STAFF REPORT

DATE: 09/23/2024
TO: Honorable Chair and Commissioners
FROM: Planning and Development Department

PP2023-0007 (CONTINUED): Precise Plan application for the review of the site plan, architecture, landscaping and other features associated with the development of a 4,110-square-foot automated carwash tunnel with 11 vacuum stalls, gas station with five double-sided fuel pumps, and a 3,725-square-foot convenience store proposed on 1.40 acres, located on the north side of 2nd Street, approximately 450 feet west of Buena Vista Avenue. (Applicant: Greens Development, 16530 Bake Parkway, Suite 200, Irvine, CA 92618)

Project Concerns and Responses

2ND STREET GAS STATION DEVELOPMENT PEDESTRIAN CONNECTIVITY

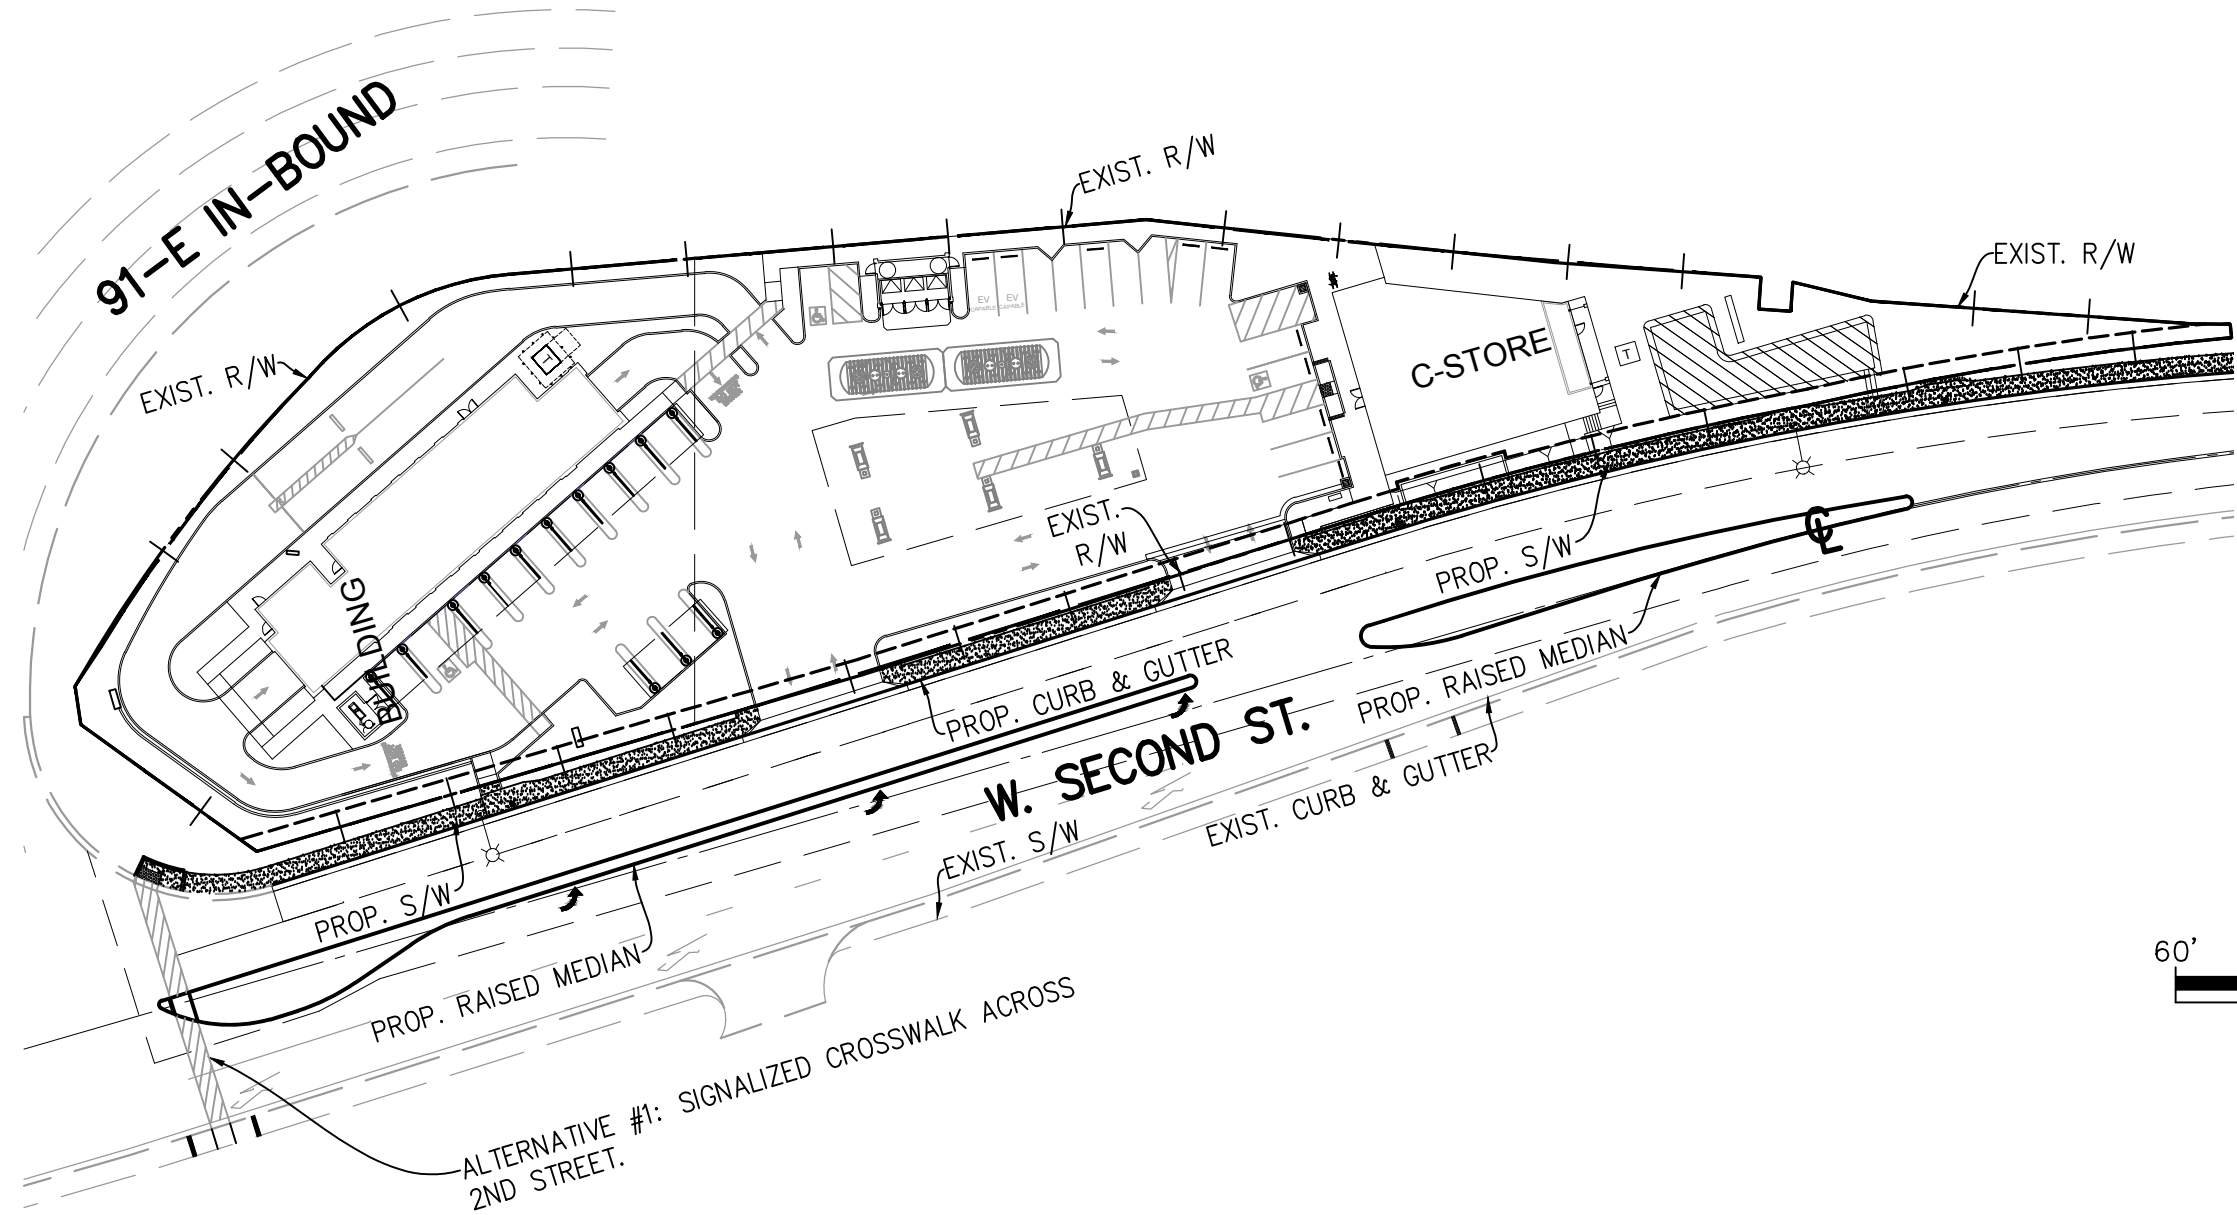
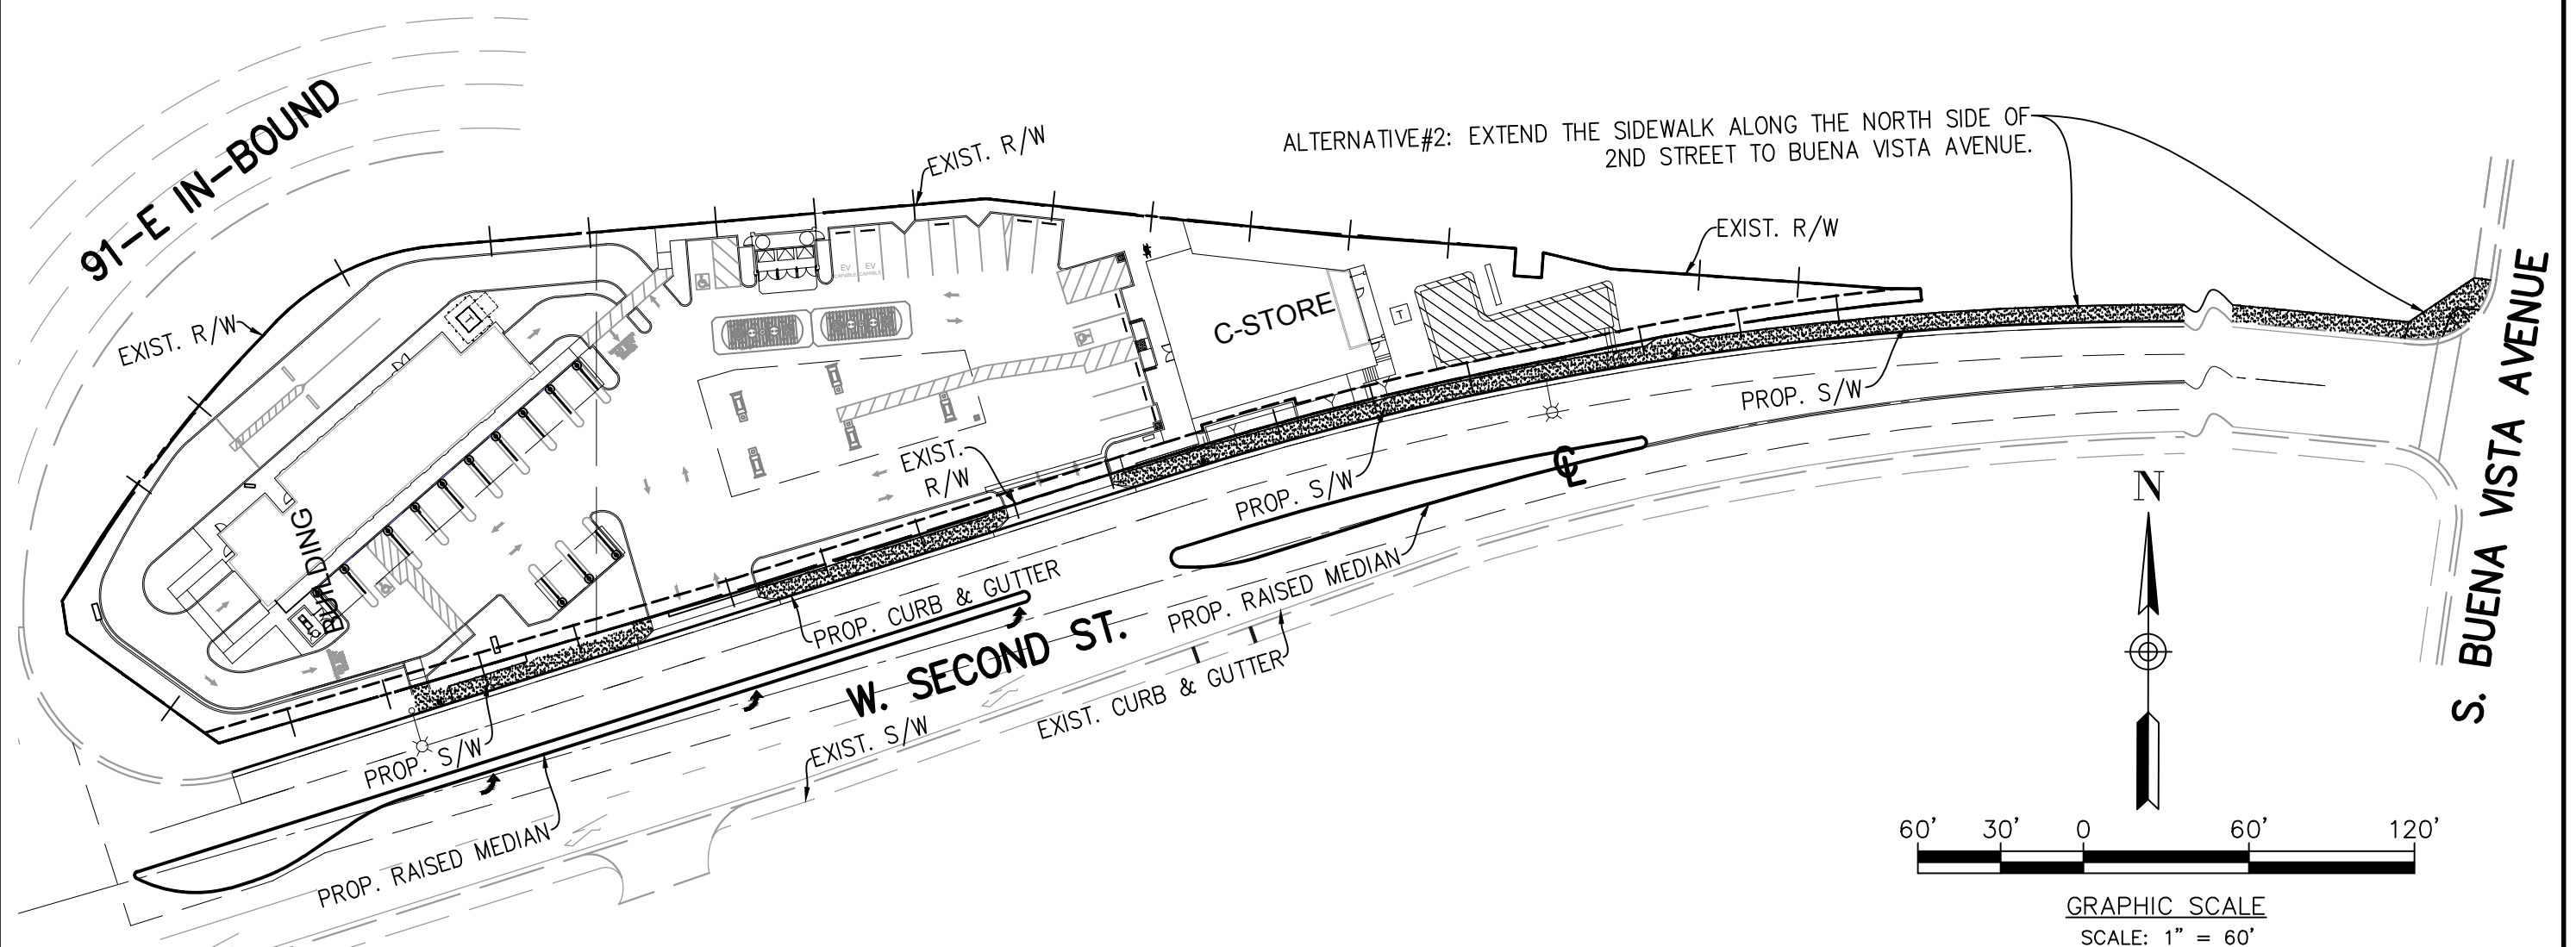
Review a potential alternate location for a crosswalk on 2nd Street to provide pedestrians access to the project site or provide signage directing pedestrians to a signalized crosswalk to prevent j-walking on 2nd Street.

- **Response:** The Supplemental Traffic Impact Analysis (Trams Solutions, dated September 5, 2024) analyzed three options for the placement of a pedestrian crosswalk on 2nd Street:

Option 2 – Under Option 2, an uncontrolled painted/lighted crosswalk on 2nd Street between the project site and Buena Vista Avenue would be installed to allow pedestrians to cross 2nd Street in an uncontrolled, marked crosswalk. Trams Solutions did not recommend this option because it would provide a false sense of security for pedestrians to believe that an oncoming vehicle will stop. The distance between the SR-91 on/off ramp and Buena Vista Avenue is about 1,100 feet. Since the crossing would be located between these two intersections, the relatively short distance to either intersection may not allow appropriate time for pedestrians to cross. Furthermore, a horizontal curve along 2nd Street exists in the vicinity of the crossing area and could reduce the visibility of drivers to pedestrians.

As there is currently no sidewalk on the north side of 2nd Street between Lincoln Avenue and Buena Vista Avenue, the Development Services Division is requiring the applicant to construct a pedestrian crosswalk at the intersection of 2nd Street and the SR-91 eastbound on-ramp to provide pedestrian connectivity from the south side of 2nd Street to the project site. The applicant will need to obtain approval from Caltrans for the crosswalk since the crosswalk would require a modification to Caltran's traffic signals at this intersection. Per the conditions of approval, in the event the applicant is unable to obtain approval from Caltrans, the applicant shall construct a sidewalk along the north side of 2nd Street from the project easterly limits to Buena Vista Avenue to provide pedestrian connectivity to the site. Exhibits depicting the pedestrian connectivity at both locations are attached as Exhibit 10.
